From: Emma Broad
Sent: 18 October 2022 16:47
To: Sarah Hill
Subject: RE: P/2022/0798 - Riverside Stud

From: Sarah Hill <Sarah.Hill@wrexham.gov.uk>
Sent: 18 October 2022 14:59
To: Emma Broad <Emma.Broad@wrexham.gov.uk>
Subject: P/2022/0798 - Riverside Stud

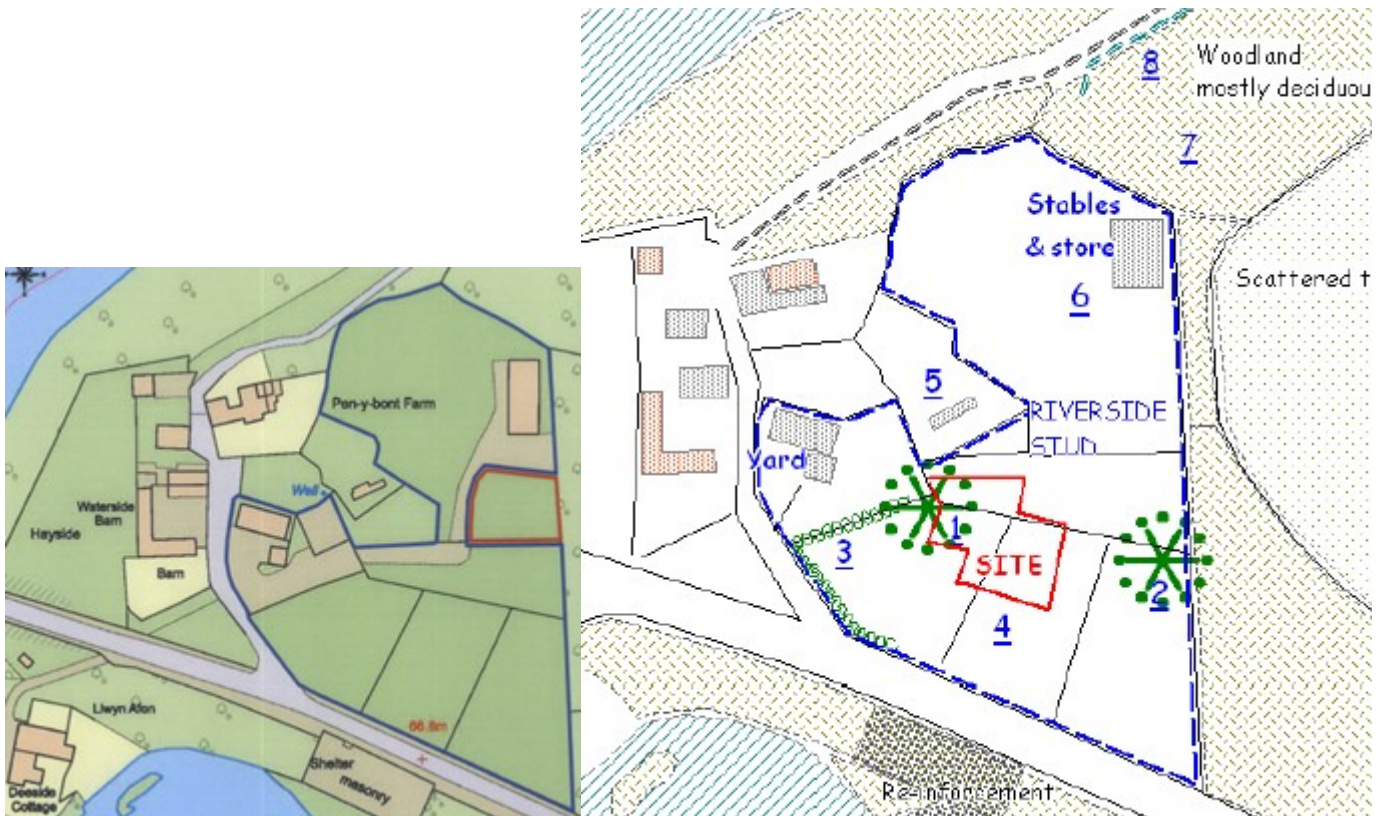
We note that the ecological report submitted in support of the above application (Land at Riverside Stud Newbridge, Wrexham Proposed Development Initial Habitat and Species assessment. Camlad Ecology Ltd. February 2021) found that protected species were not using the site. However, the report does not relate to the exact application site, but to a nearby plot of land that was the subject of a previous planning application. We therefore advise that you liaise with your own Authority's ecologist regarding this.

The two plans are compared below. Surely we need to ask for a new ecological assessment covering the correct area?

There doesn't look to be any overlap between the 2 sites so will definitely require a new survey.
